<p align="center"><b>COA #</b>  <b>2015-COA-243 (FP)</b>  <b>2015-VHP-023</b></p>	<p align="center"><b>INDIANAPOLIS</b>  <b>HISTORIC PRESERVATION COMMISSION</b>  <b>STAFF REPORT</b></p>	<p align="center"><b>Hearing Date</b>  <b>OCT. 22, 2015</b></p>
<p align="center"><b>638 VIRGINIA AVE</b>  <b>FLETCHER PLACE</b></p>		<p align="center"><i>Continued from:</i>  <i>Oct. 7, 2015</i>  <i>July 1, 2015</i>  <i>August 5, 2015</i>  <i>August 19, 2015</i>  <i>September 2, 2015</i></p>
<p><b>Applicant &amp; mailing address:</b></p>	<p>Craig McCormick/ Blackline  1 N. Meridian Street, Studio 400  Indianapolis, IN 46204</p>	<p align="center">Center Twp.  Council District: 19  Jeff Miller</p>
<p><b>Owner:</b></p>	<p>638 VA LLC  6402 Cornell Ave  Indianapolis, IN 46220</p>	
<p align="center"><b>COMBINED CASE</b></p>		
<p><b>IHPC COA: 2015-COA-243 (FP)</b></p>	<p>Approval of a Certificate of Appropriateness for:</p> <ul style="list-style-type: none"> <li>• Construction of an outdoor seating/deck area</li> <li>• Rear addition</li> <li>• Parapet</li> <li>• New storefront system</li> <li>• Site improvements</li> <li>• Restoration of building</li> <li>• Add window openings</li> <li>• Dumpster with enc

**SITE PLAN**

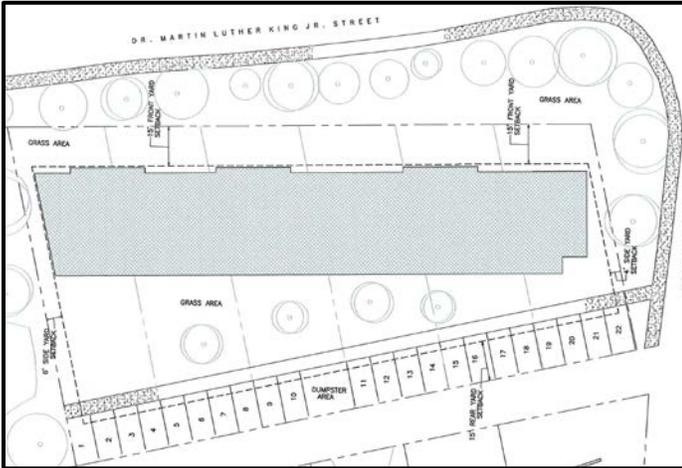
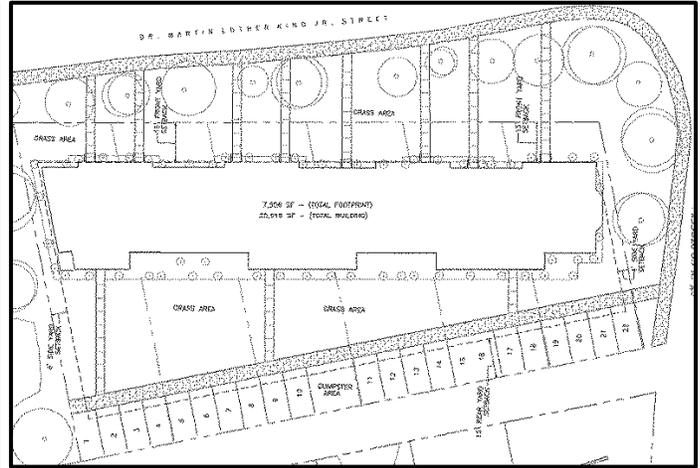
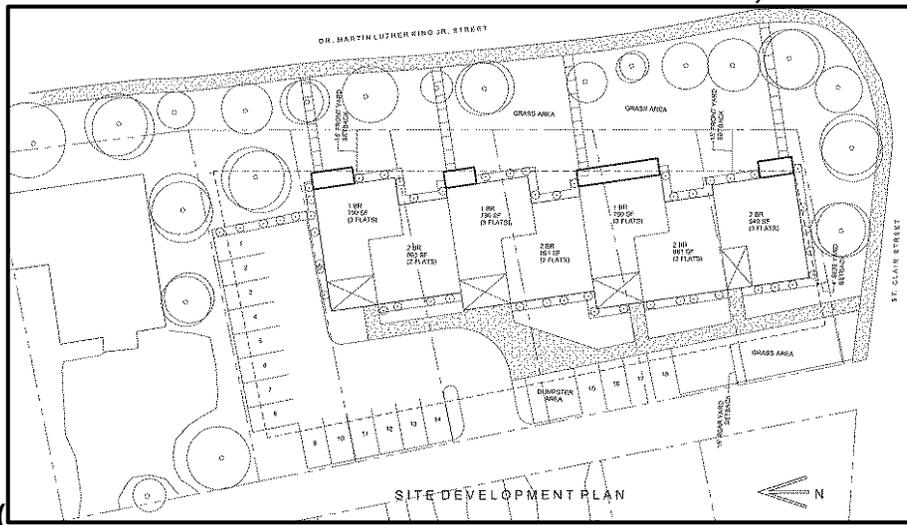
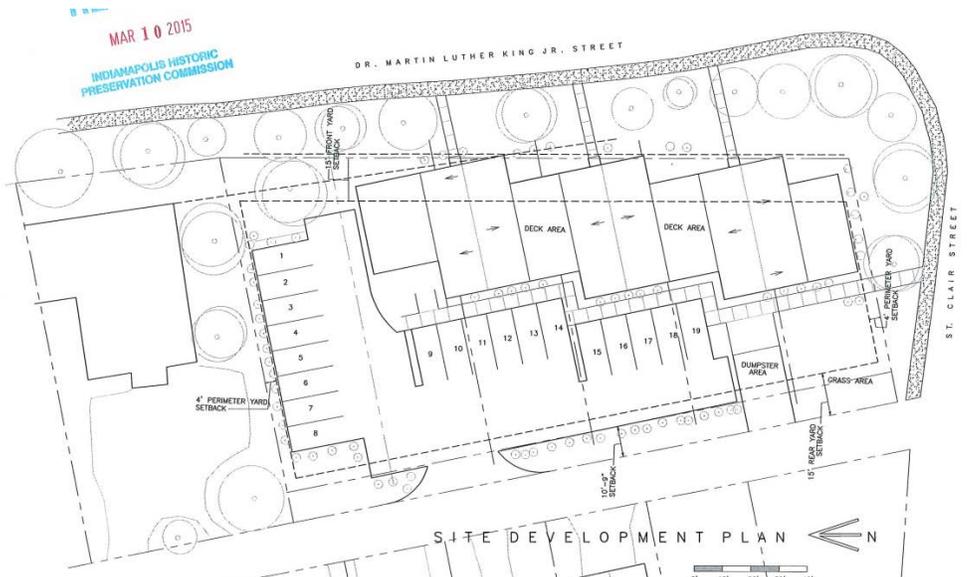
Lancer + Beebe Architects have re-thought this project and studied the previous comments by staff and commission members. They have come up with a design that is significantly different and reflects an understanding of the direction suggested by staff and commission. Major changes include:

1. Instead of one large 3-story building, the proposal now is broken up into four buildings, three of which are only 2 stories.
2. A 3 story “apartment-style” building with 8 units is at the corner of MLK and St. Clair, is separated from the historic houses on MLK by two 2-story “townhouse-style” buildings with 4 units each.

3. One “carriage house-style” building is on the alley. The ground level is for parking, and the second floor houses two 1-bedroom apartments.
4. Parking has been returned to the alley, but is set back 10 ft. from the alley to reduce the dangers of backing directly into the alley.

5. The new site plan includes open yard space at the rear.
6. Care has been taken to screen stairwells and locate them in non-prominent locations.
7. Only the 3-story building on the corner has a roof top deck. The 2-story buildings nearest neighboring properties do not have any outdoor decks.

**PREVIOUS GROUND FLOOR PLAN**

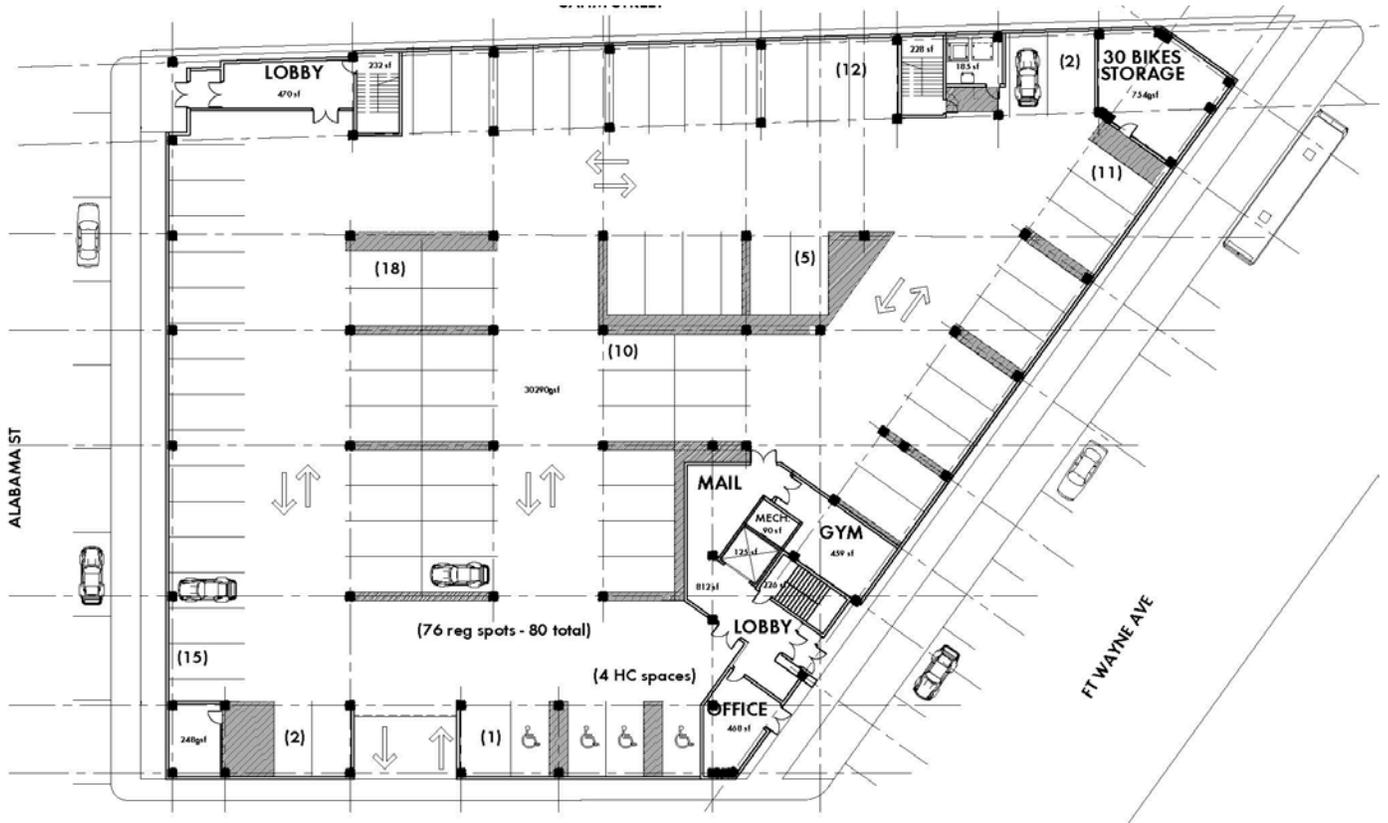
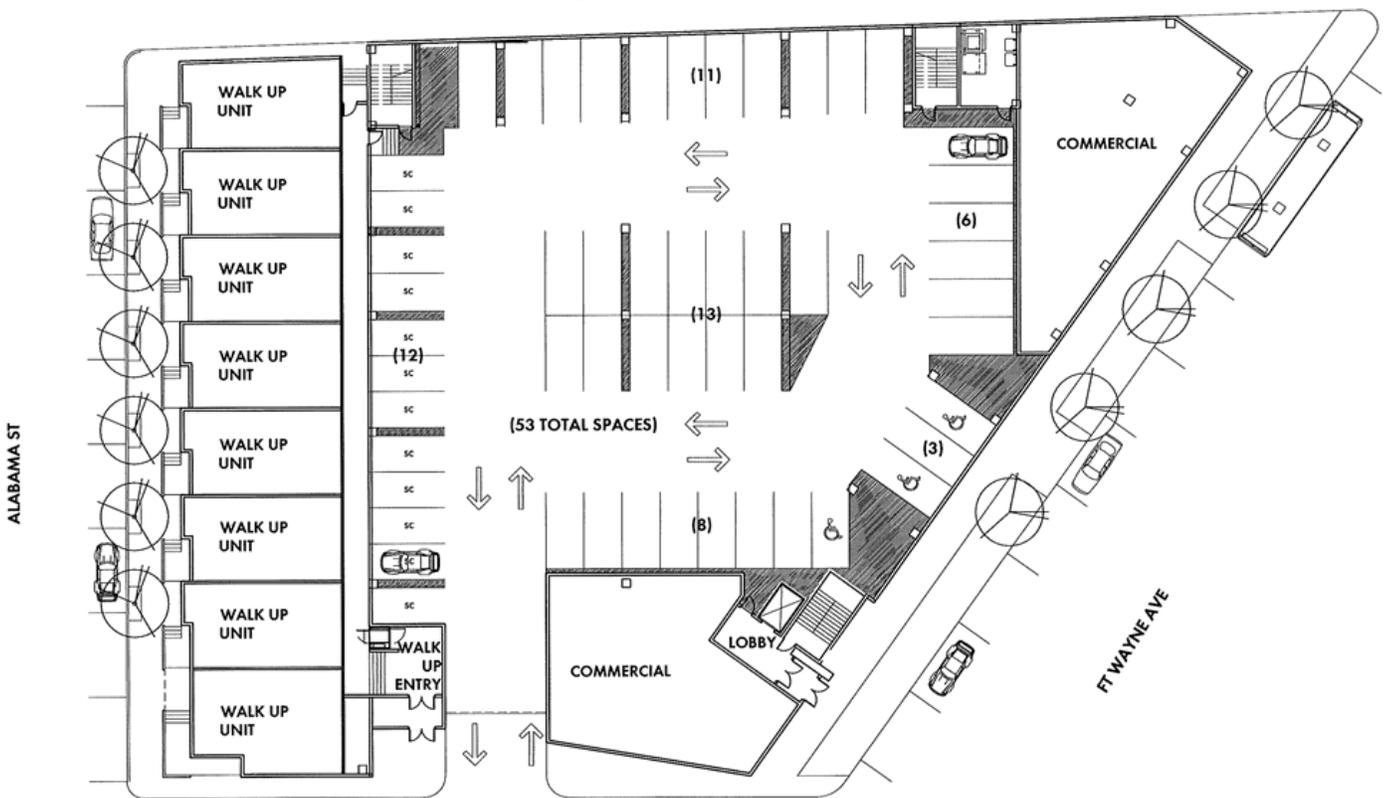
The first floor will now contain two commercial spaces along with the previously proposed parking garage. The lobby space has been reduced and the leasing office, gym and bike storage area have been eliminated to accommodate the added commercial space. The parking garage will no longer be visible along Alabama St. Where it is visible on other sides, it will be concealed by the use of a metal screen which the architect is showing as having an optional vegetation wall. The first floor also contains aluminum storefront windows.

North elevation, as approved 9/2/15

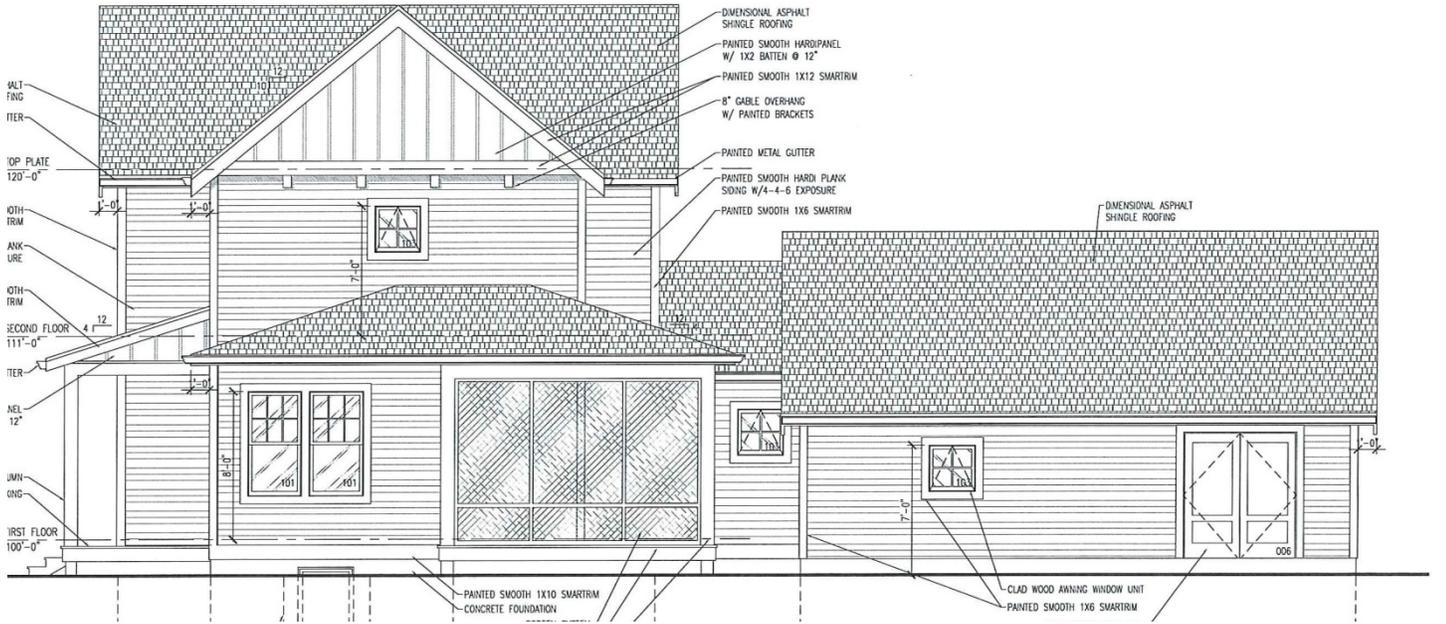
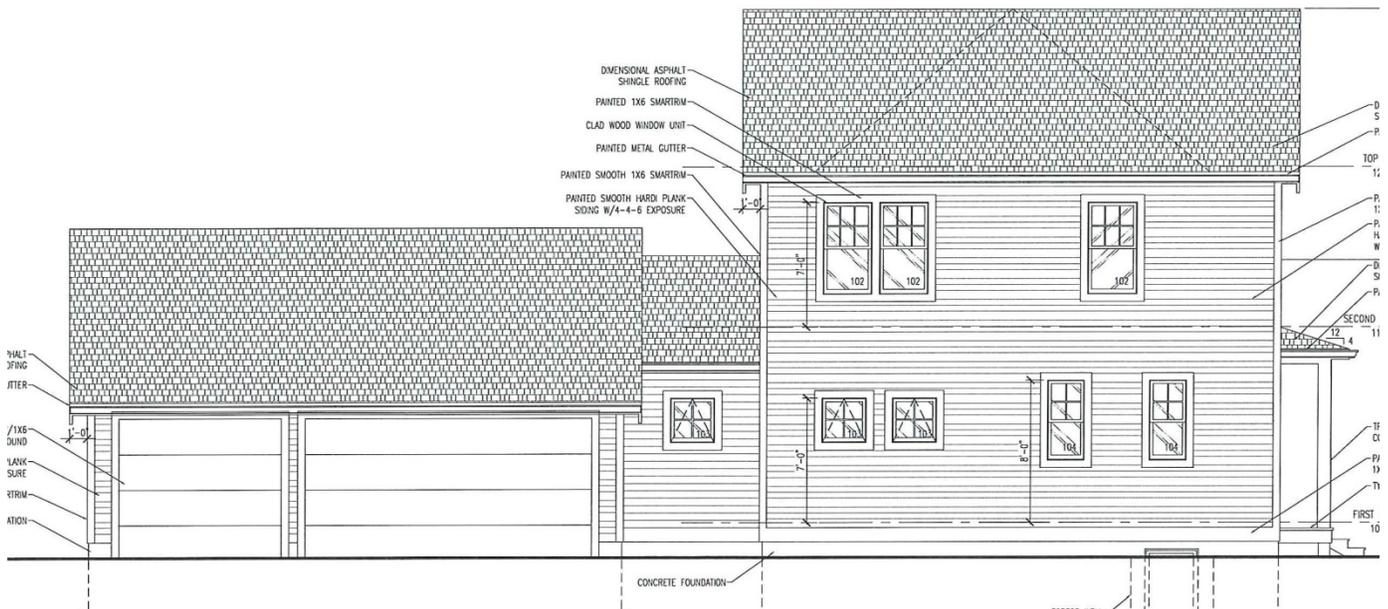
The design and the amended plans were executed by Demerly Architects. No changes are proposed to the main house other than the addition of the 8 ft. x 12 ft. mudroom connector at the rear. The mudroom is recessed from the walls of the house and garage, in order to keep the main masses distinct from one another. The mudroom is a continuation of the design of the main house.

1. The amended proposal reflects the guidance in the Cottage Home Plan regarding placement and design of attached garages.
2. The approved design of the house and garage remain nearly identical to what was approved in September, aside from a small connector addition between the two buildings.
3. The garage connector is not visible from Stillwell (the primary elevation), and has been kept to the secondary, alley façade as recommended in the Plan.
4. The massing of the garage and the house are kept distinct by the intentional recess of the connector.

**To approve revised plans showing the garage attached to the house by an enclosed mudroom.**
